1964 Corvette: Service Bulletin: Directional Signal Switch Service

Subject: Directional Signal Switch Service

Bulletin No: DR #693, Section XII

Date: September 8, 1964

SERVICE INFORMATION

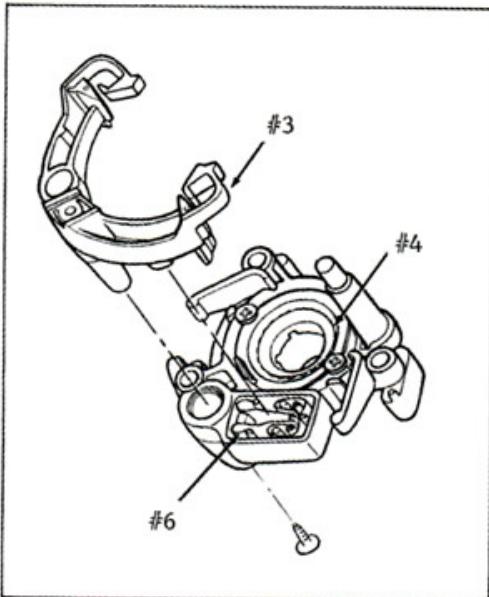
1. Diagnose the problem as one that involves the directional signal switch, and eliminate other possible causes before removing the steering wheel (See attached "Trouble Shooting" guide).
2. Disconnect battery and remove the steering wheel per Shop Manual Instructions. On Chevelle Models, remove the retainer, spring and cancelling cam.
3. Remove the directional signal operating lever.
4. Remove the three (3) switch retaining screws and lift the switch enough to disengage the shifter tube housing.
5. Follow shop manual procedures of disassembly until the switch harness can be pulled out far enough to gain access to the actuating plate screw and remove the screw and actuating plate.

Any of the following components may be replaced without complete switch replacement; cancelling cam, actuating plate, upper mast jacket bearing and contactor kit.

1964 CHEVELLE ONLY

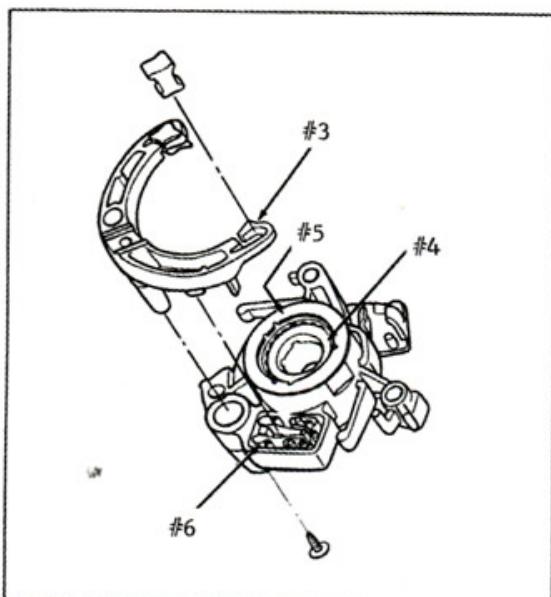
A third type of switch assembly is used optionally on Chevelles. This switch is a die cast metal design, identified by cast letters "BPC", and is serviced only as an assembly, Part Number 383033. It is interchangeable with the plastic service switch 910372 only if housing 383688 or 383689 housing is also used.
